Meeting Regarding Hender #3 & Seminole Electric

TO: Buck Oven, P.E. Administrator
FROM: *John Brown Jr*
John Brown, P.E. Administrator
DATE: November 16, 1994
SUBJECT: Seminole Electric Cooperative Incorporated (SECI)
Hardee Unit 3 - PA89-25SA, Mod 8035
PSD-FL-214

Revised Pages for Replacement into Hardee Unit 3
Site Certification Application/Environmental Analysis

SUBJECT: SECI Hardee Unit 3 Sufficiency Response

Figure 5
 Cross Section of the Wetland Creation Site
 (Revised 10/12/94)

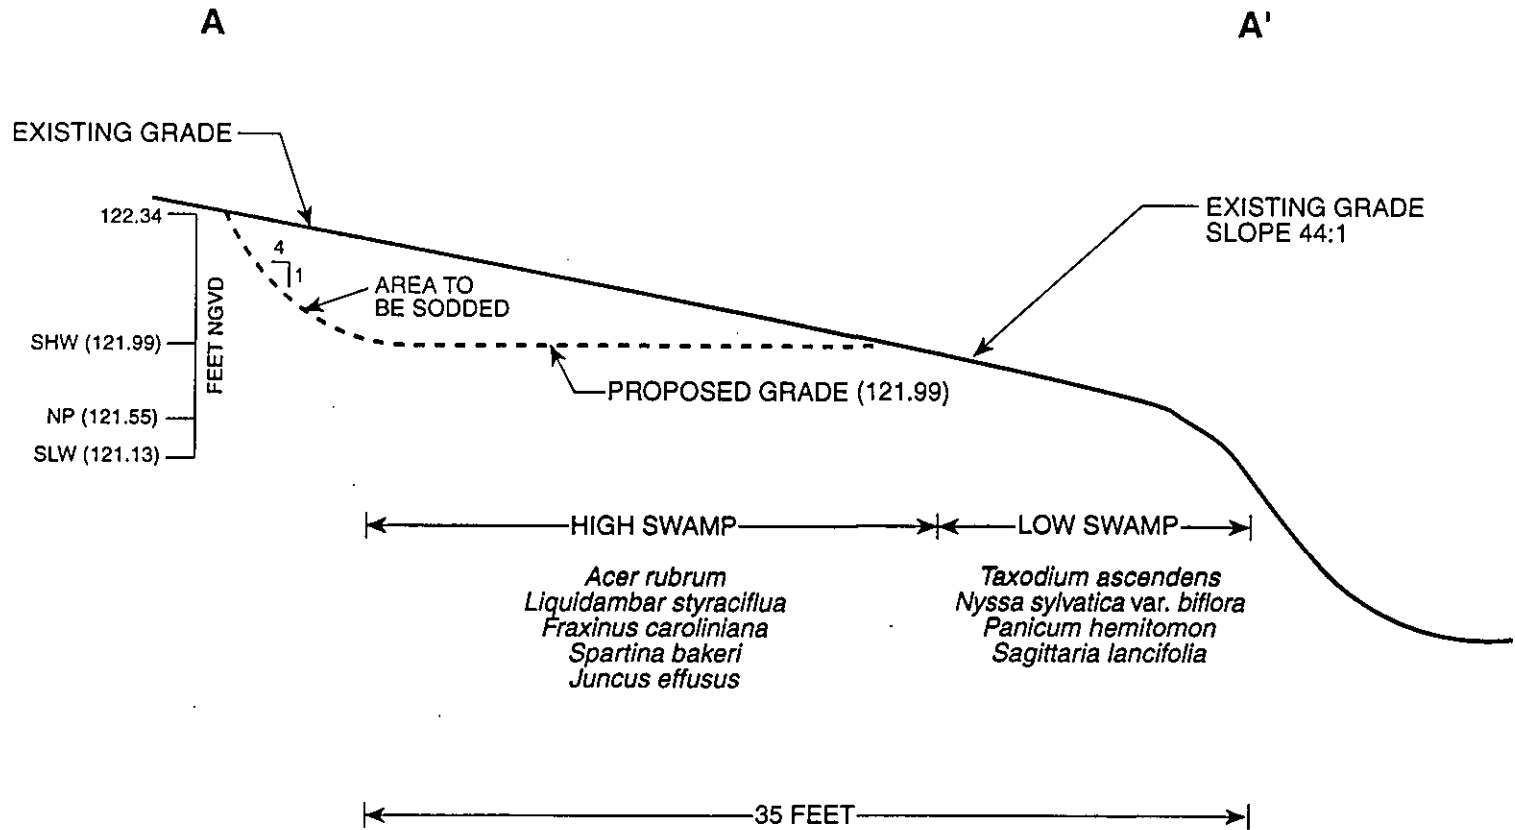
2. Based upon the presence of nuisance and upland species in the mitigation area, the existing ground cover will not be acceptable as part of the mitigation proposal. Mulching and/or planting details are needed for the mitigation area. Details should include plan and cross-sectional views showing limits of each distinct zone in reference to proposed control elevations, mulching, proposed plantings (species, sizes, densities and relative composition) within each zone, proposed water elevations (SHWL and NP), bottom elevations, and slopes. SWFWMD-2

Response: Detailed grading plans have been prepared and are depicted in the attached revised wetland mitigation plan (see Figure 5). The entire mitigation area is at or below the seasonal high water level elevation.

Figure 7
Detailed Plan View of Wetland Creation Area

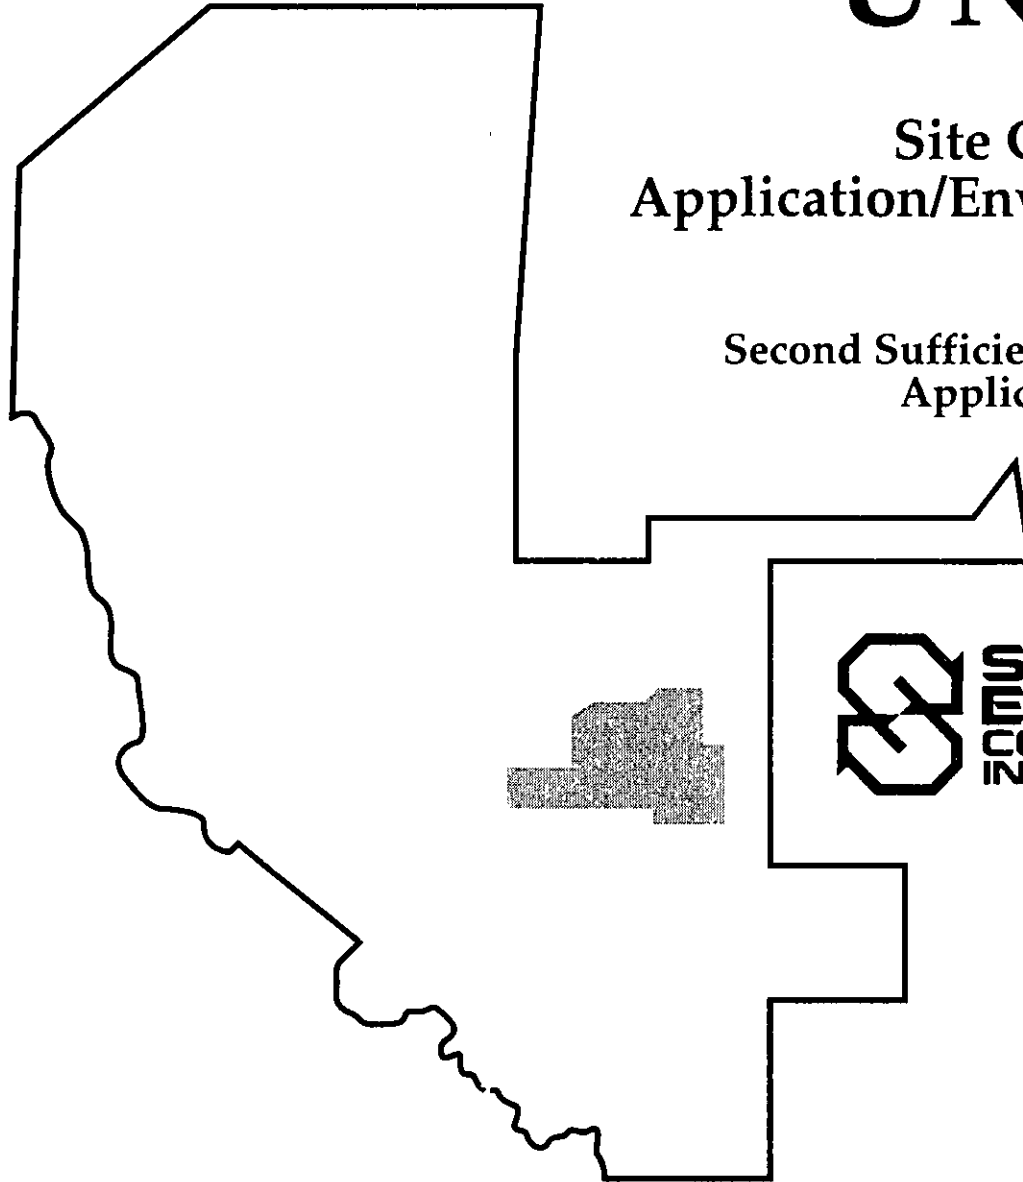
3. A detailed planview of the mitigation area is needed. Details should include views showing limits of each distinct zone in reference to proposed control elevations, proposed plantings (species, sizes, densities and relative composition) within each zone, and mulching details.

Response: A revised planview of the mitigation area has been prepared and is included as Figure 7 in the attached revised wetland mitigation plan.

Figure FDEP.BWRM-8
 Plan View of Retainment Berm, Stormwater Pond, Entrance
 Roads, and Access Road Where Wetland Impacts Will Occur
 (Revised 10/06/94)

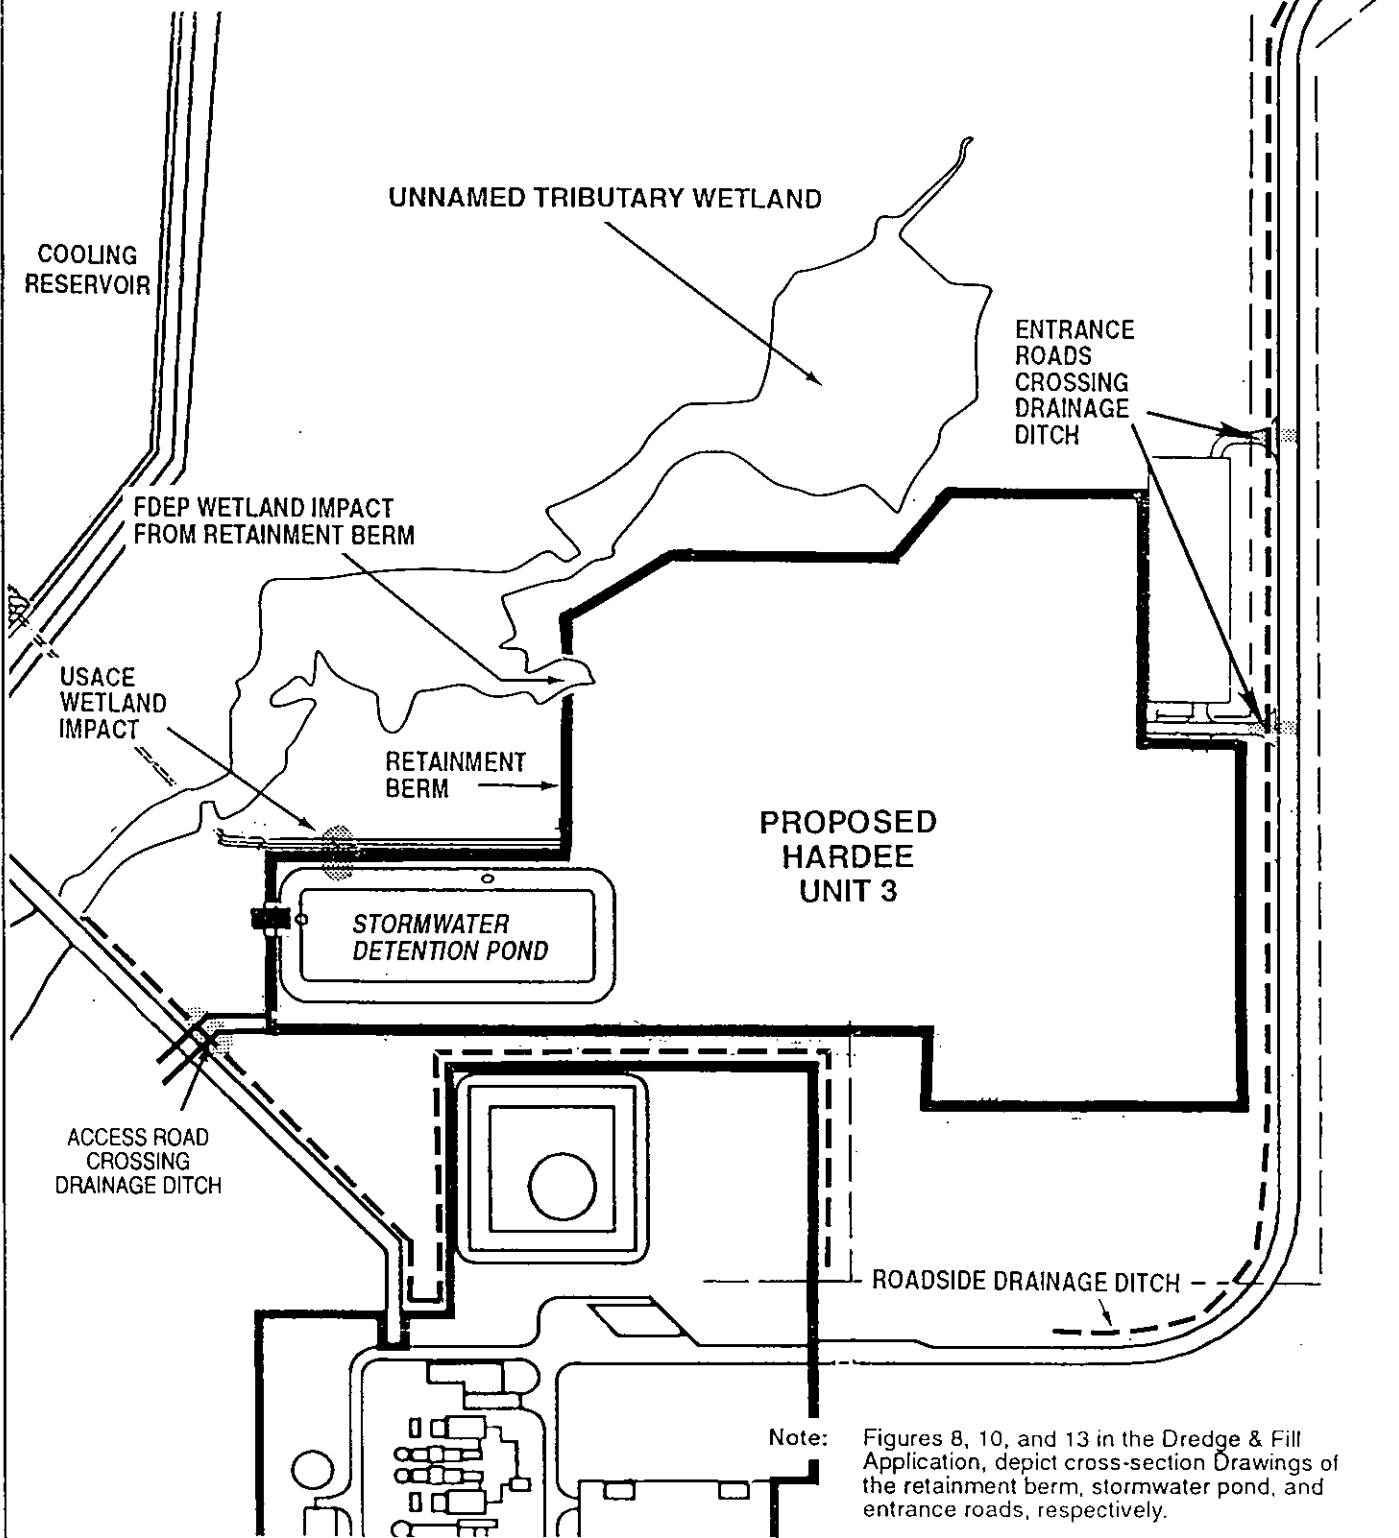
Comment: Figure 9 shows a road crossing a jurisdictional drainage ditch southwest of the detention basin. This ditch crossing is not shown on Figure FDEP.BWRM-8. Please revise the appropriate drawing to resolve this conflict and submit the revised drawing to the Bureau.

Response: Figure FDEP.BWRM-8 has been revised and is attached.

Figure 4
 Plan View of Mitigation Sites
 (Revised 10/12/94)

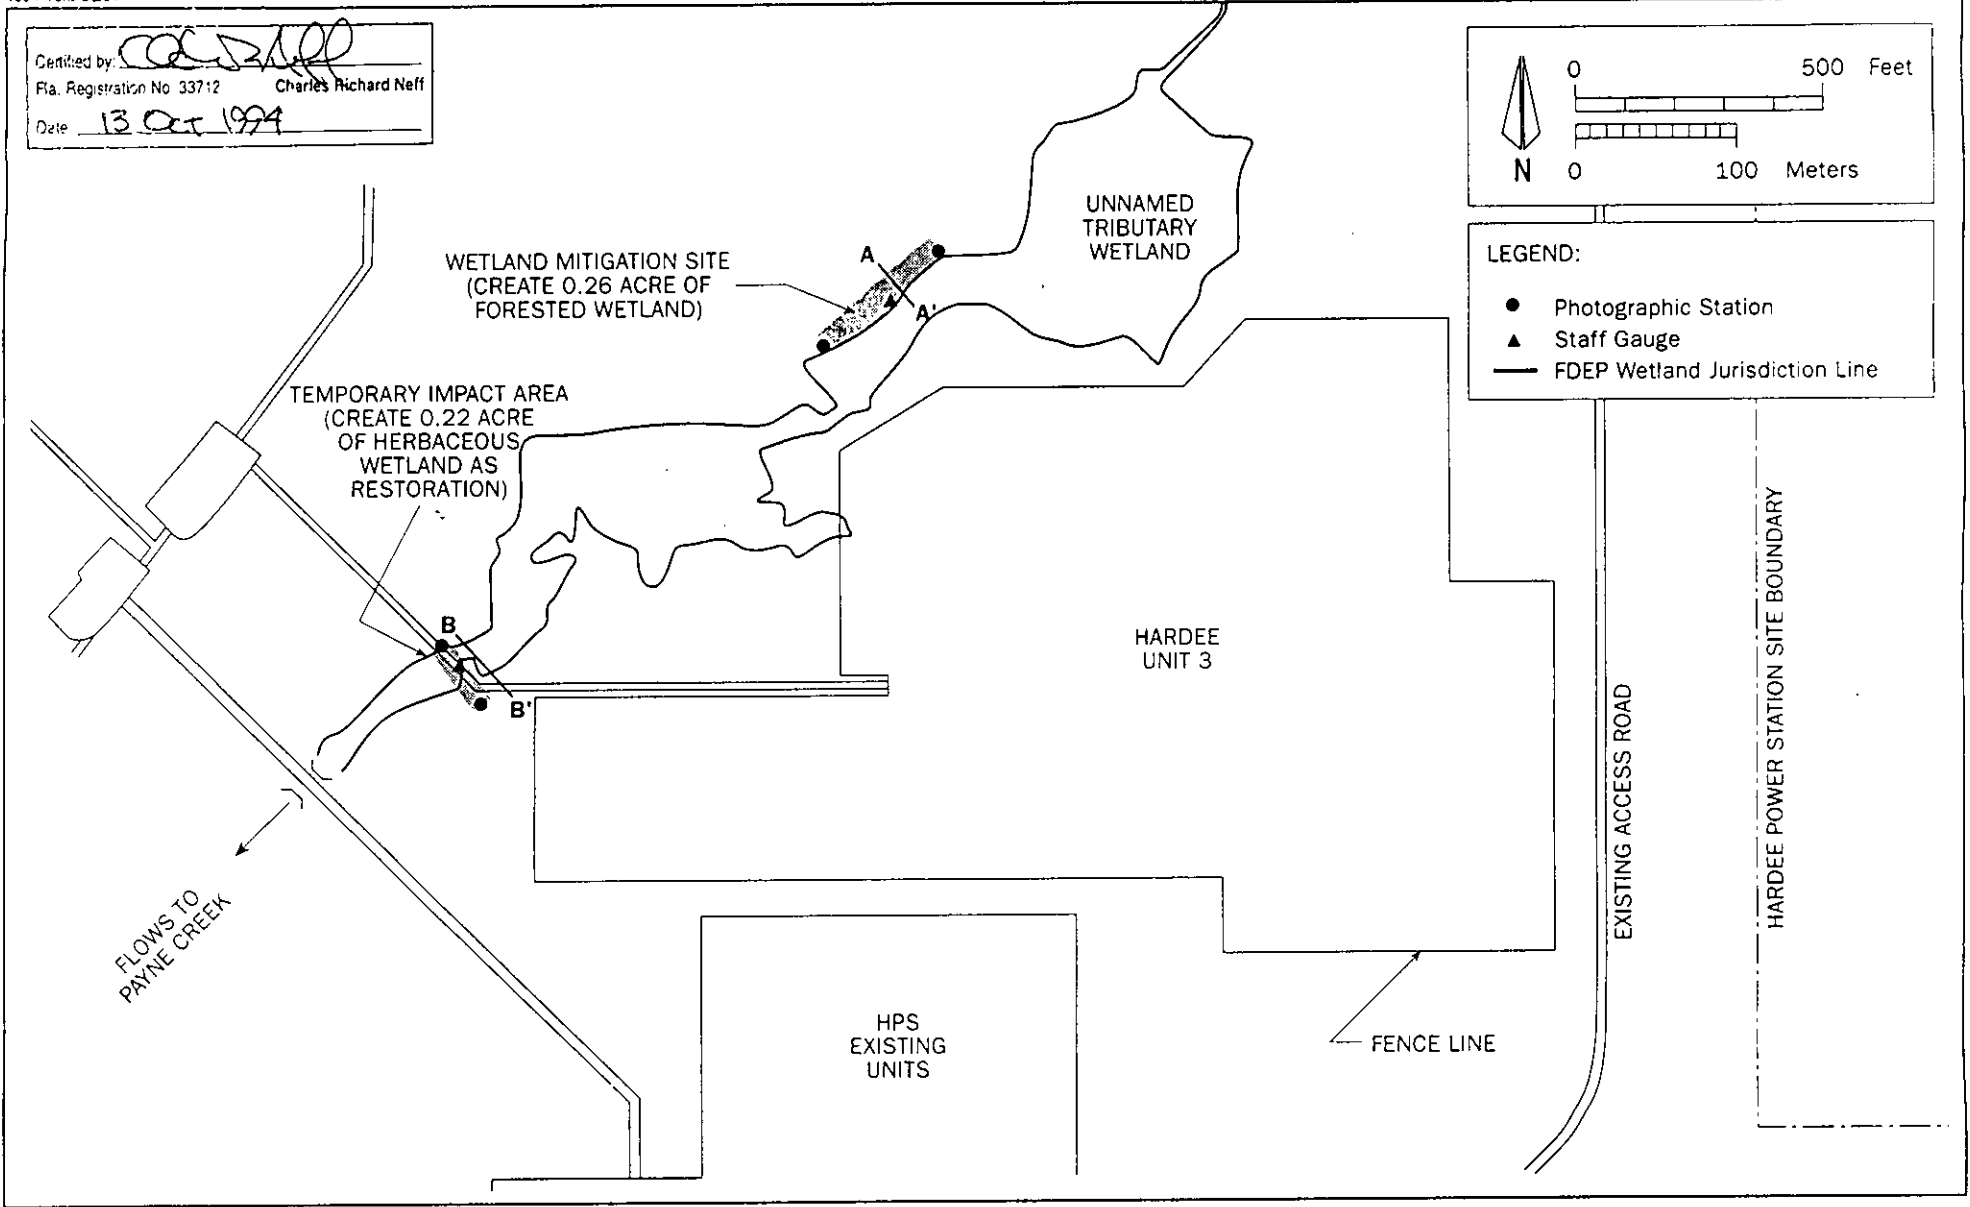
Comment: Please revised Figure 4 to label the wetland restoration area as a temporary impact area. The current labeling indicates that the pipeline crossing is a mitigation area rather than an area of temporary impact that will be restored.

Response: Figure 4 has been revised and is attached.
